**ADDENDUM 1
CSP 23-26
GYMNASIUM ADDITIONS/IMPROVEMENTS FOR
BETTS & KENNEDY ELEMENTARY SCHOOLS
November 9, 2022**

Addendum Number 01

Edinburg CISD Gymnasium Addition & Renovation Project –
John F. Kennedy Elementary & Melissa Dotson Betts Elementary
CSP 23-26

PBK Project No.: 220019

S3.0

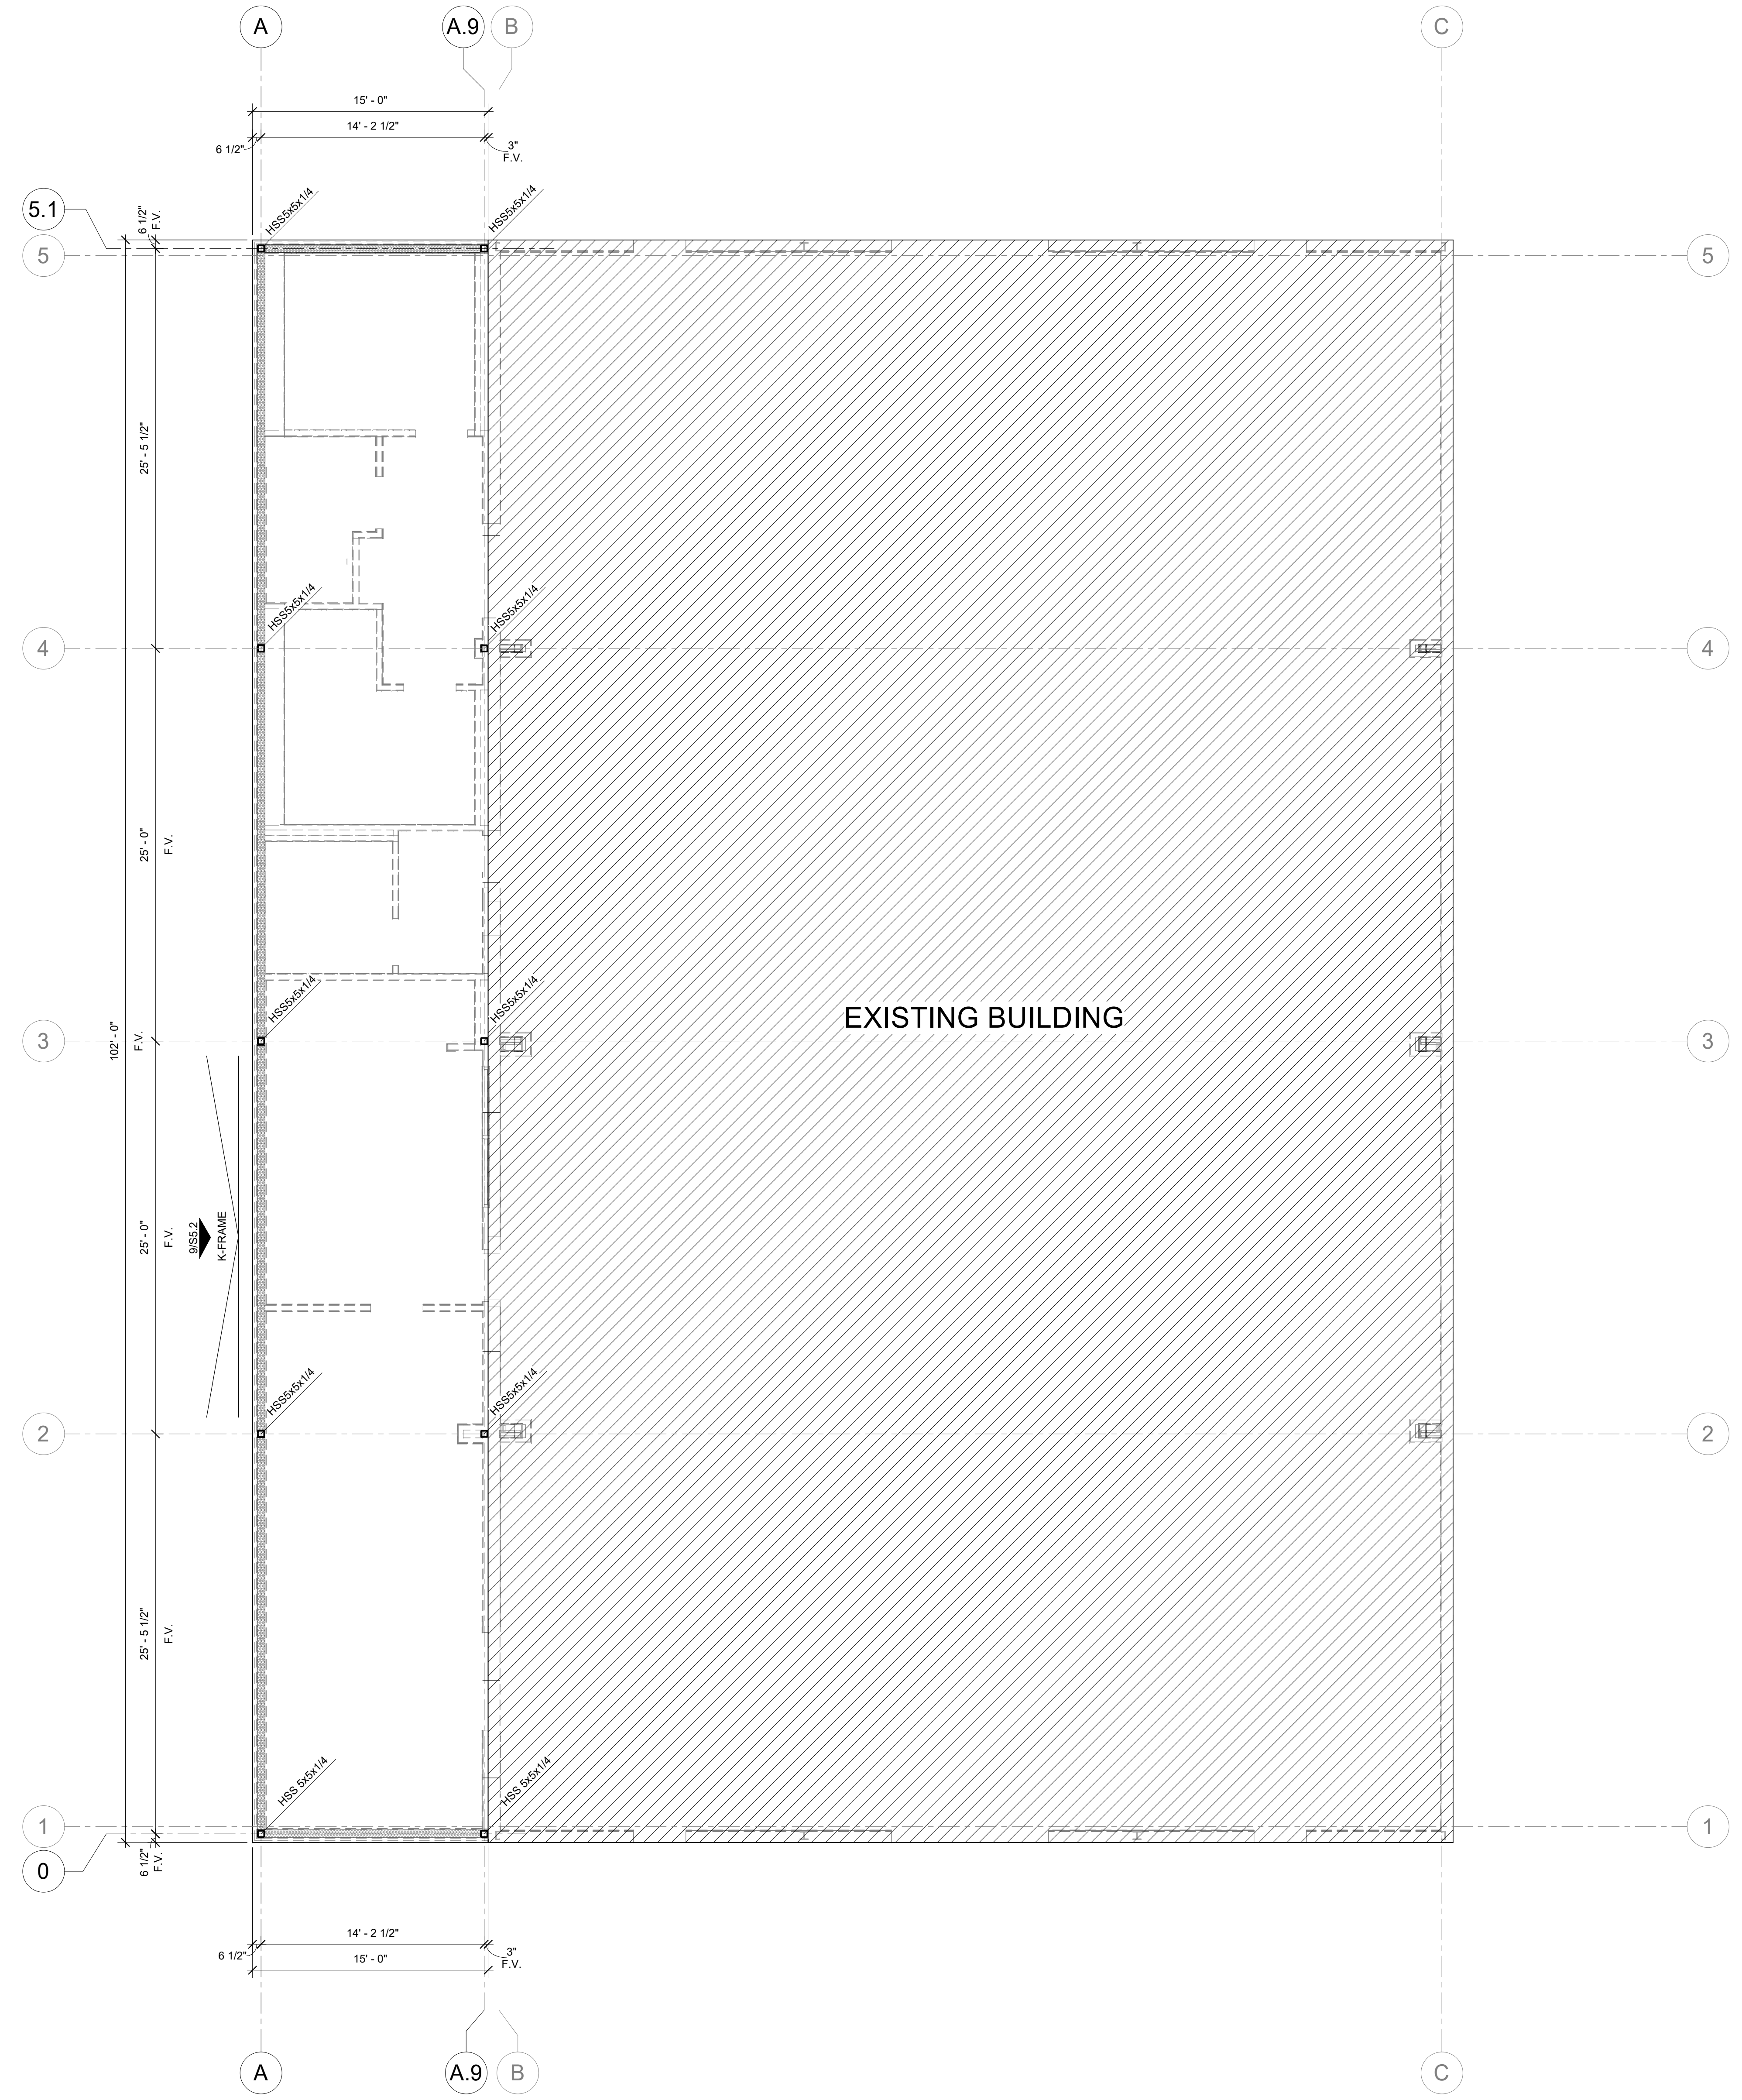
- Item No. 05:** Sheet S3.0: WALL LAYOUT PLAN. (John F. Kennedy Elem.)
Add sheet S3.01.
- Item No. 06:** Sheet S4.0: ROOF FRAMING PLAN. Delete in its entirety. (John F. Kennedy Elem.)
Replace with revised sheet S4.0. Notes & details have been updated.

AD501

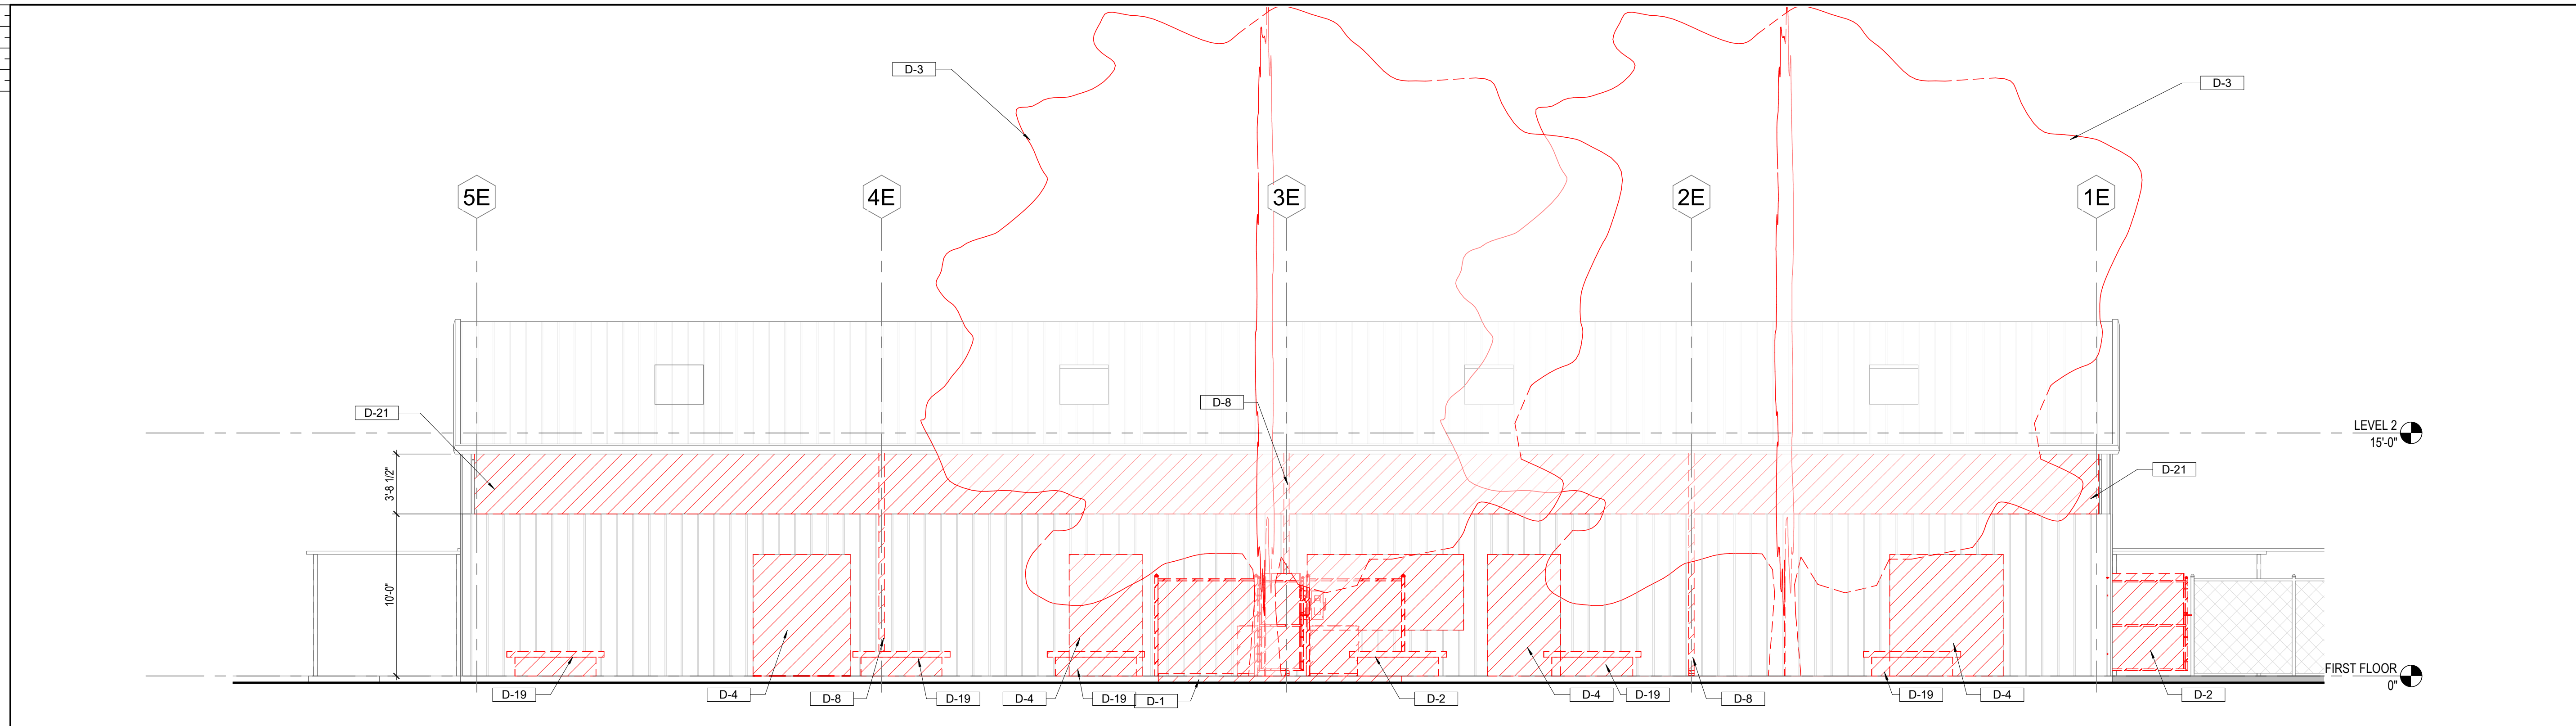
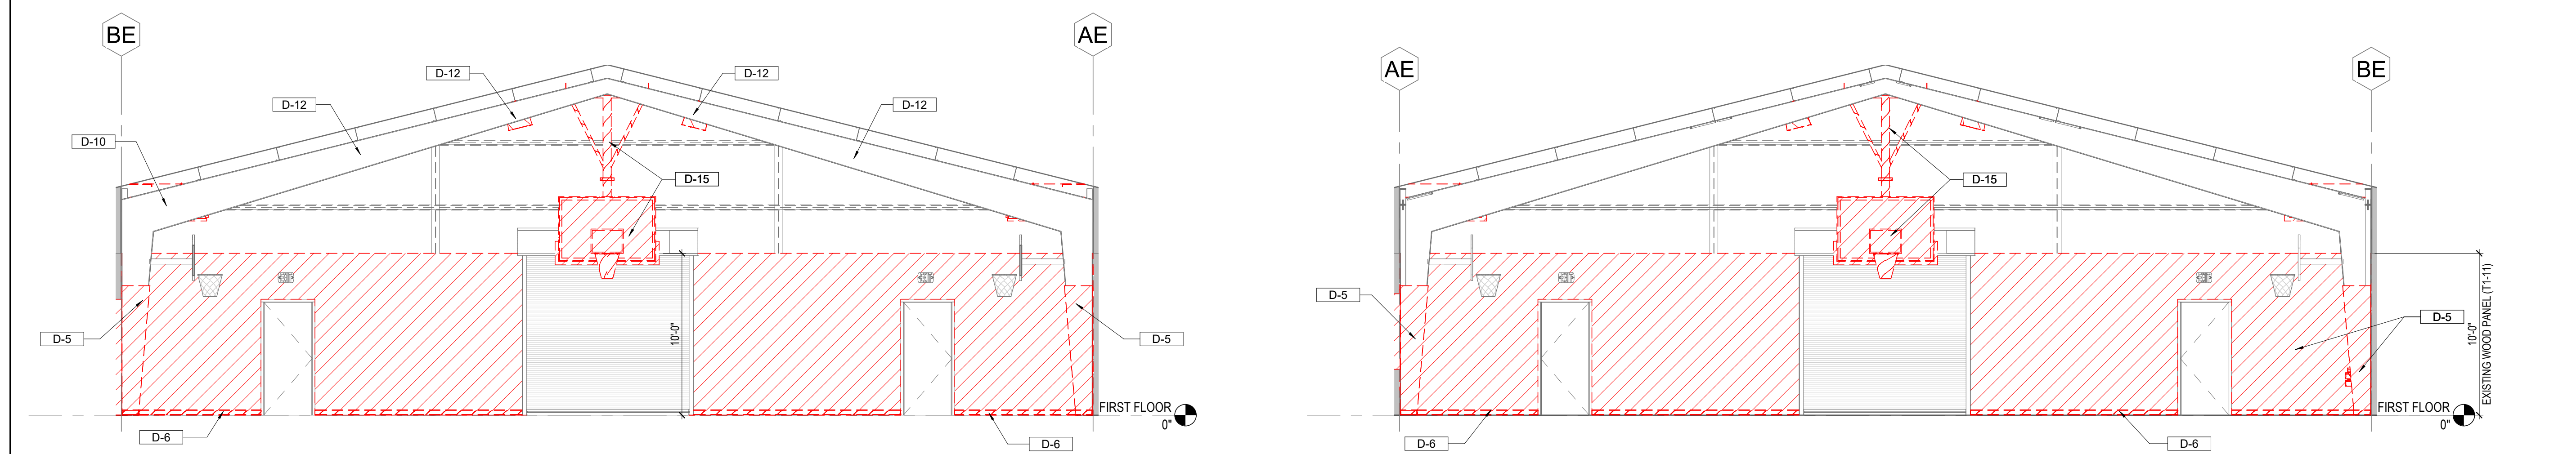
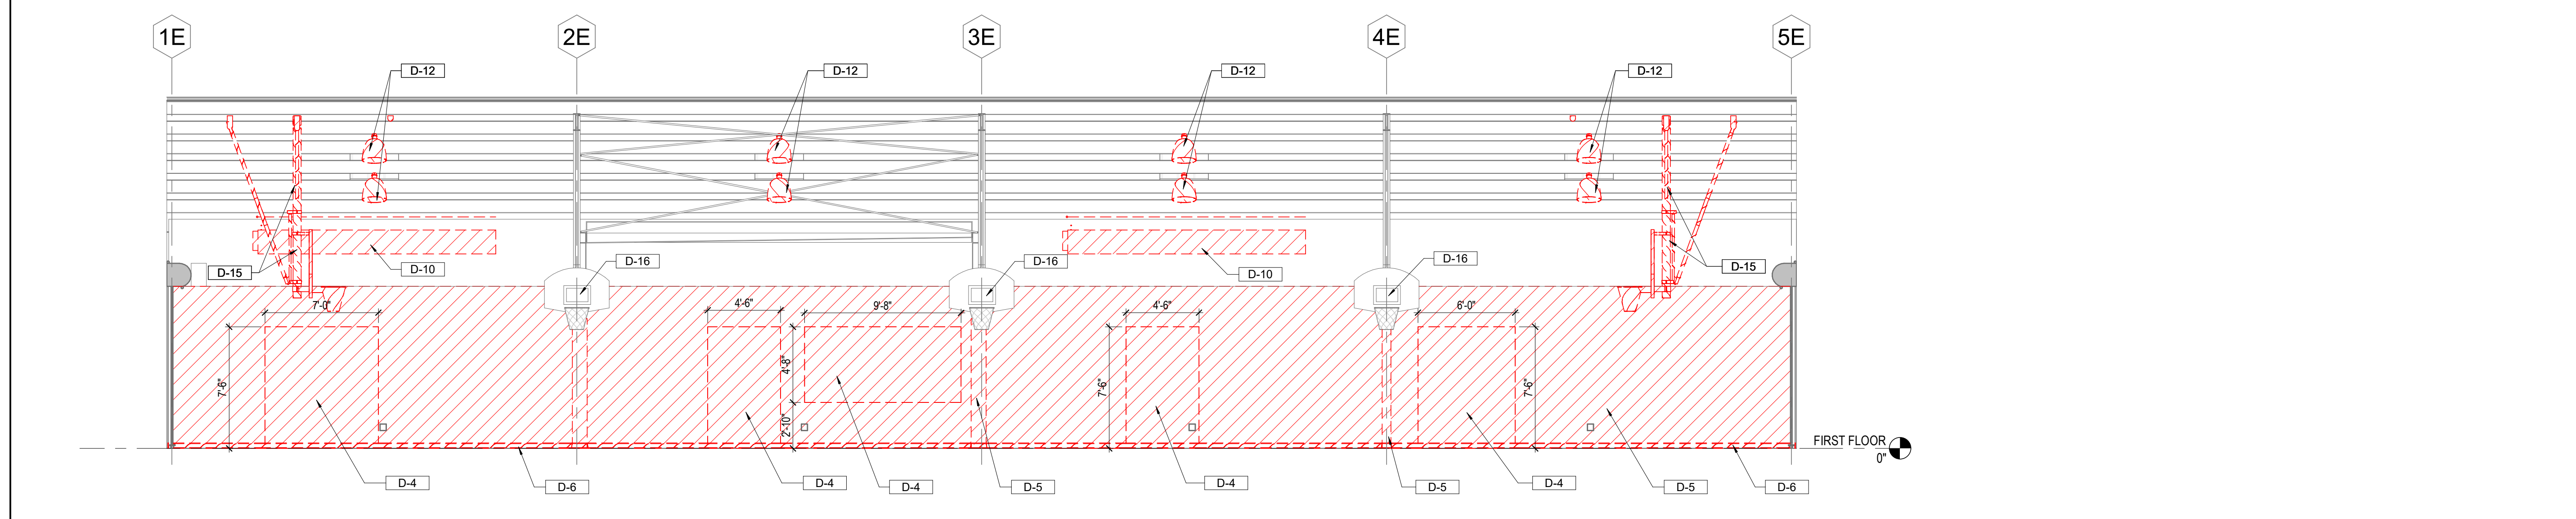
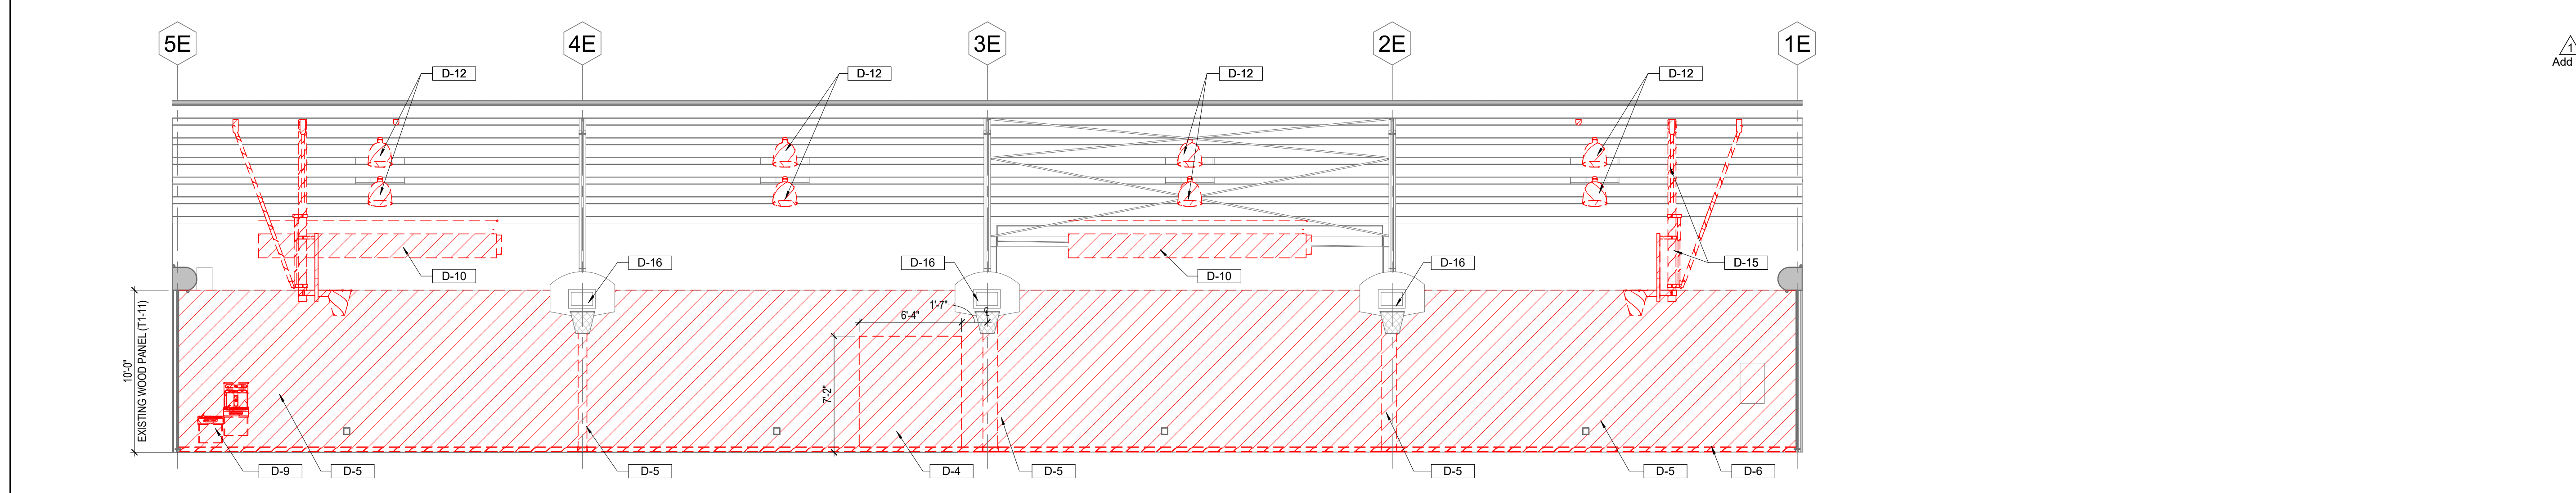
- Item No. 09:** Sheet AD501: DEMOLITION EXTERIOR & INTERIOR ELEVATIONS. Delete in its entirety. (John F. Kennedy Elem.)
Replace with revised sheet AD501. Demo notes have been updated.
